SUBJECT: SUSQUEHANNA STEAM ELECTRIC STATION, UNITS 1 AND 2 - RELIEF  
REQUESTS FOR THE FOURTH 10-YEAR INSERVICE INSPECTION  
INTERVAL (TAC NOS. MF2705 THROUGH MF2714)

SAFETY EVALUATION BY THE OFFICE OF NUCLEAR REACTOR REGULATION

REGARDING RELIEF REQUESTS 4RR-02, 4RR-05, 4RR-06, 4RR-07, AND 4RR-08

SUSQUEHANNA STEAM ELECTRIC STATION, UNITS 1 AND 2

Figure 1

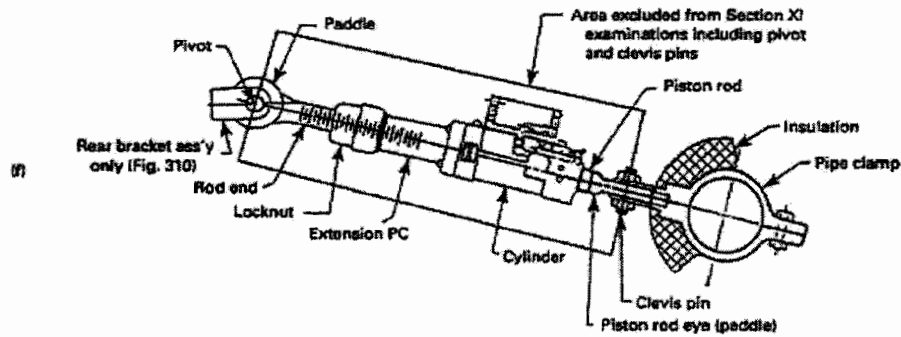
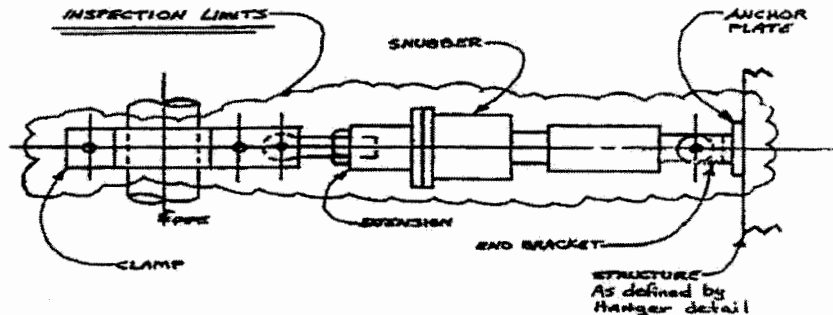
The 2007 Edition through the 2008 Addenda of ASME Code Section XI contains Figure IWF-1300-1(f), which depicts the examination boundaries for a snubber (as shown in Figure 1 above). The boundaries indicate that the attachment of the snubber to the pressure boundary and building structure is required to be examined in accordance with IWF-2000, whereas the excluded snubber (pin-to-pin) is to be examined per ASME OM Code.

The licensee states that in order to eliminate the duplication of effort by tracking two different examination boundaries for one component, SSES, Units 1 and 2, requests an alternative to establish one examination boundary as shown in Figure 2 above.

The NRC staff reviewed all the information provided in the licensee's submittal and its response to the RAIs, and found the proposed examination boundaries of snubber and attachments, as shown in Figure 2 in lieu of Figure 1 boundaries, to be acceptable based on the following:

1. Incorporating both examination boundaries (snubbers and their attachments) into one program provides a better understanding of the condition of snubber and its associated attachments, without sacrificing any quality and safety.

2. SSES, Units 1 and 2, will be using VT-3 qualified personnel for both snubbers and its associated attachments. Performing both visual examinations of snubber and its attachments under the proposed boundaries in the snubber program using VT-3 qualified personnel to perform examinations provides a better understanding of the snubber and attachments.

3. The 2004 Edition through the 2005 Addenda of the ASME Code, did not specify any boundaries between snubber and its attachments. In the 2006 Addenda of the ASME Code, new boundaries between the snubber and its attachments were introduced via Figure IWF-1300-1(f), because the snubber (pin-to-pin) examination and testing requirements were moved into the ASME OM Code. Visual examination of snubber attachments by VT-3 qualified personnel meets the inspection requirement of ASME Code Section XI, 2007 Edition through the 2008 Addenda.

4. ASME OM Code Case OMN-13 requires 100 percent of the safety-related snubbers to be examined and evaluated at least once every 10 years. Now, based on the proposed boundaries of Figure 2, SSES, Units 1 and 2, will also perform 100 percent visual examination of snubber attachments along with the snubbers. This exceeds the requirements of the ASME Code Section XI, IWF-2500-1 tables (for attachments) which

Based on the above evaluation, and pursuant to 10 CFR 50.55a(a)(3)(i), the NRC staff finds that the licensee's proposed alternative in 4RR-06 of using boundaries as specified in Figure 2, which includes the snubber and its attachments, meets or exceeds the inspection requirements of IWF-2000 and therefore provides an acceptable level of quality and safety. Therefore, the use of the proposed alternative in 4RR-06 is authorized for the fourth 10-year ISI interval at SSES, Units 1 and 2. The snubber attachment inspections will be tracked by the Snubber Program in lieu of the ISI Program.
